# RENESAS TECHNICAL UPD

Product Category	MPU&MCU	Document No.	TN-SH7-509A/EA	Rev.	1.0
Title	SH7705 an errata on the IrDA function		Information Category	Usage Limitation	
Applicable Product	HD6417705F133, HD6417705BP133 HD6417705F133V, HD6417705BP133V HD6417705F100, HD6417705BP100 HD6417705F100V, HD6417705BP100V	Lot No.	Reference Document	SH7705 Group Hardware Manual Rev. 2.0 REJ09B0082-02000	
		All

Figure 1.

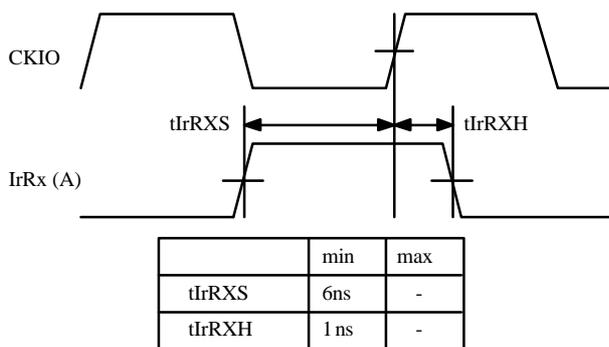
When the Serial Communication Interface with FIFO (SCIF) is used for the IrDA, it may not receive data properly.

Please synchronize the IrRx signal with CKIO(Figure 1).
